POLICY REPORT DEVELOPMENT AND BUILDING

SUBJECT: CD-1 Rezoning - 3030 East Broadway (Broadway Tech Centre East)

3030 East Broadway
PROPOSED CONDITIONS OF APPROVAL

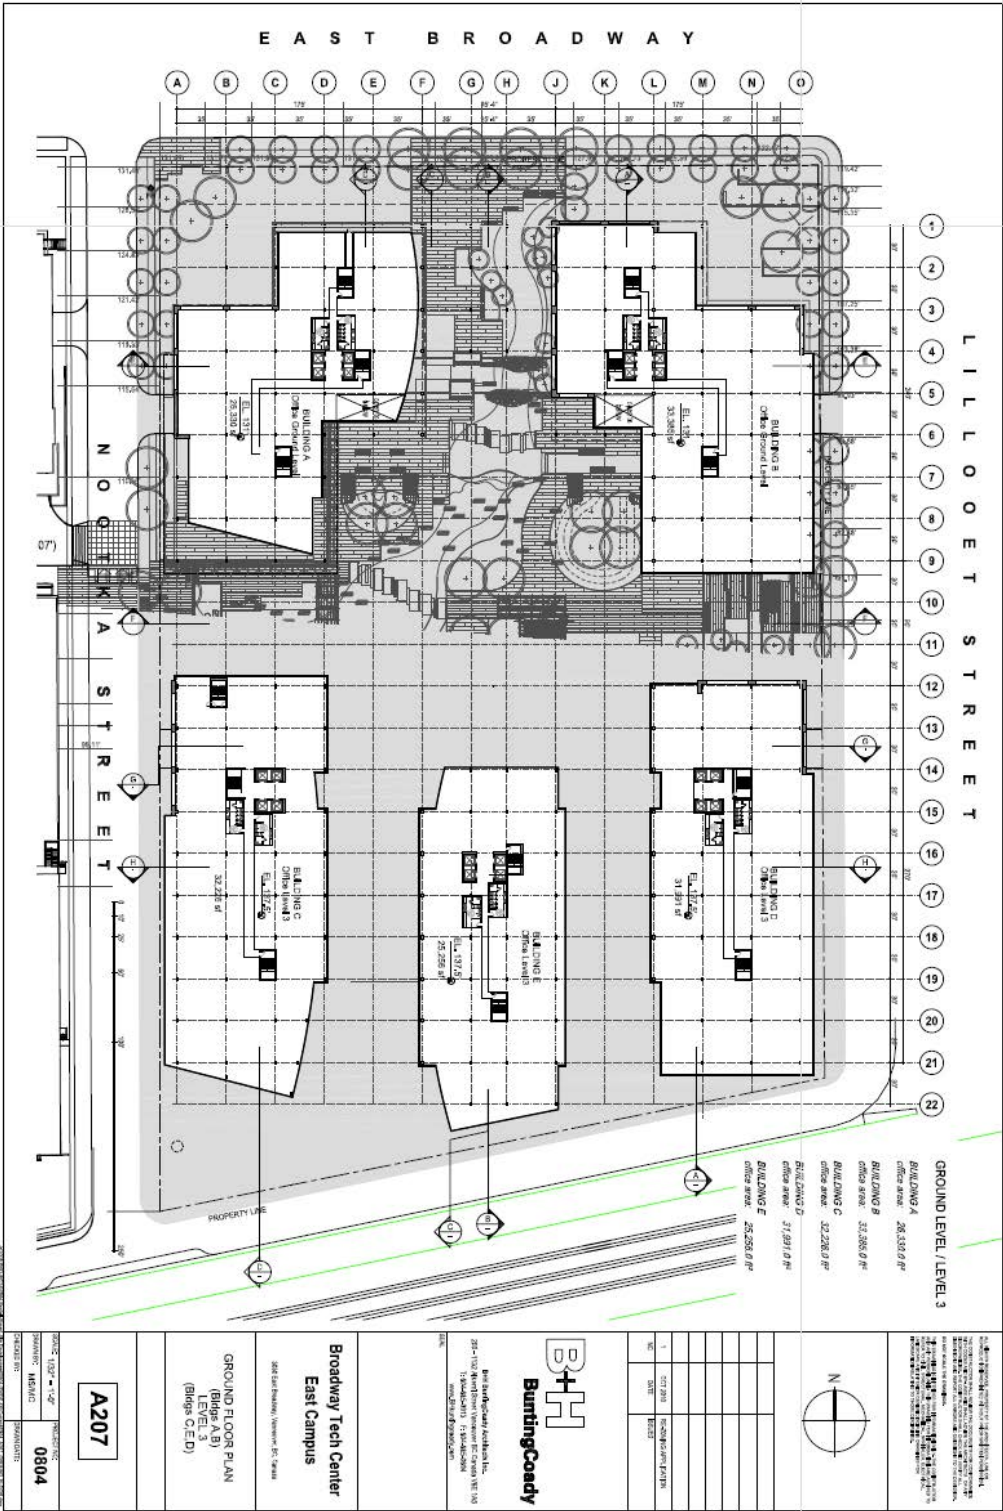
The Panel thought that the proposal had the potential to be exciting but felt that the applicant was only creating an eight hour facility where there was intensive use for the workday and then on evenings and weekend would be greatly underutilized. They encouraged the applicant to look at the ground plane where they could introduce evening or weekend facilities with retail uses such as cafes or fitness amenities.

Some Panel members thought there was a generic suburban office park look to the design and encouraged the applicant to depart from that look, using innovative ways to deal with passive design. They found the architectural forms somewhat blocky and thought the ground plane was more successful. The Panel also thought the density could be better distributed on the site.

The Panel thought that having the vehicles out of the pedestrian realm was a good idea and would increase the pedestrian emphasis of the project. As well the Panel liked the use of light wells into the parkade as it would improve the entry sequence to the office. Several Panel members thought a formalized pedestrian crossing would be needed on East Broadway.

The Panel members supported the landscape plans and liked the use of waterfalls and waterways as they will diminish the traffic noise from East Broadway. Some of the Panel felt there needed to be a larger green space area for people to use. They also liked that there were direct links to transit. One Panel member was concerned that too much energy might go to the water system and suggested the applicant find ways to animate the water without using huge amounts of energy.

The Panel commended the applicant for going for LEED™ Platinum but that the buildings needed to recognize the solar angles.

- **Applicant's Response:** The applicant team had no additional comments.

Site Plan

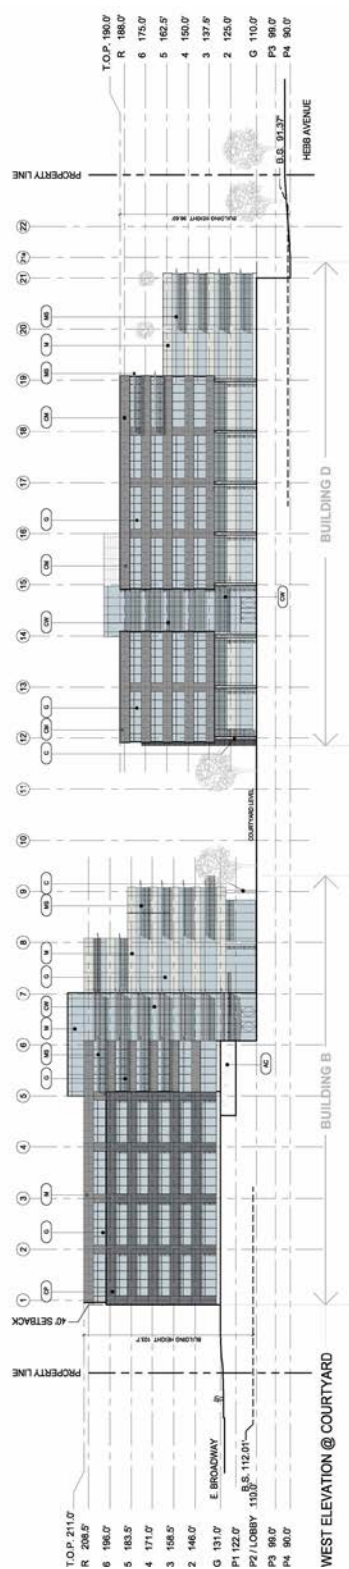
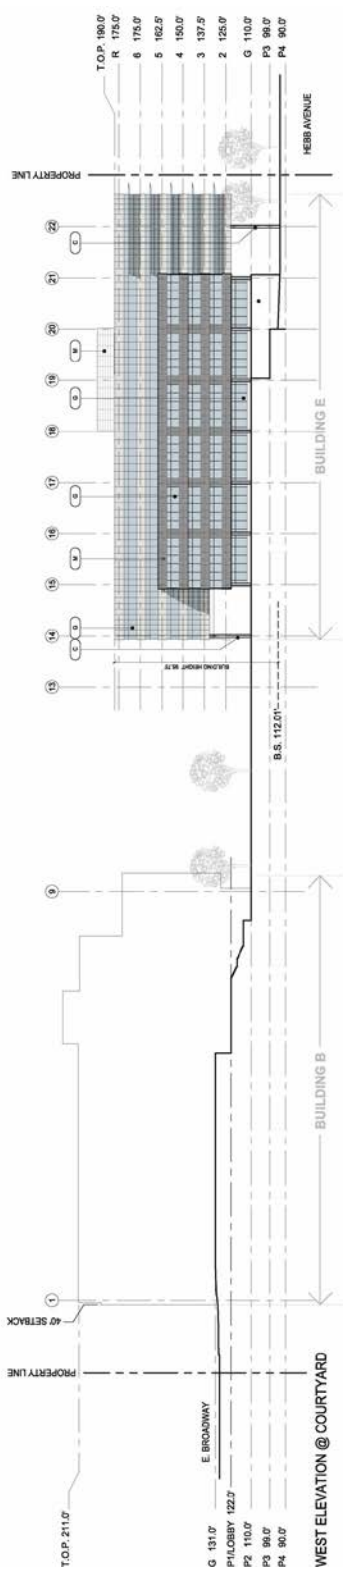
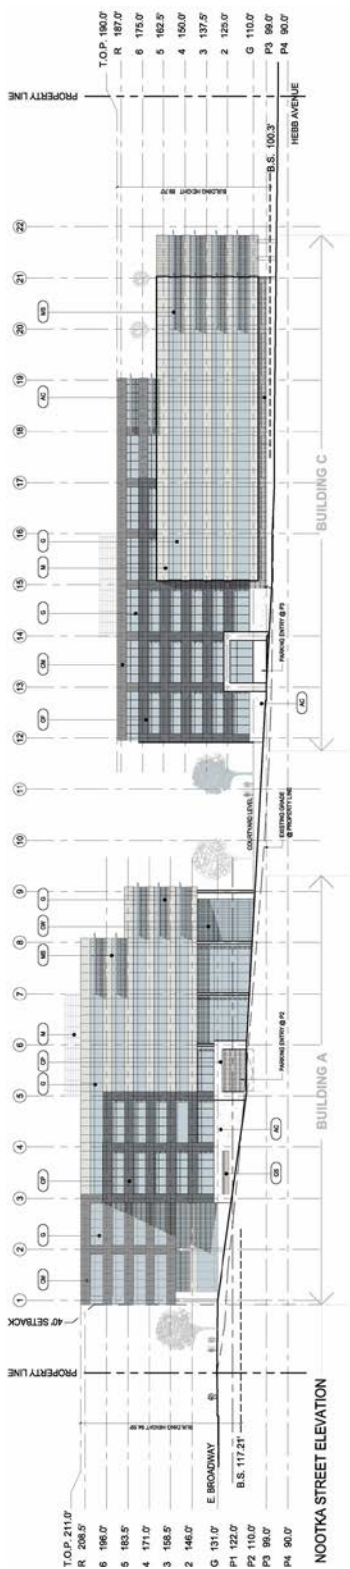
3. Identification on site plans and landscape plans of intended pedestrian routes through the site, coordinated with legal agreements to secure public passage.

35. Clarify the south property-line dimension. As shown on page A101 it is more than 3 feet longer than either City records or the surveyor's plan submitted in the original application.
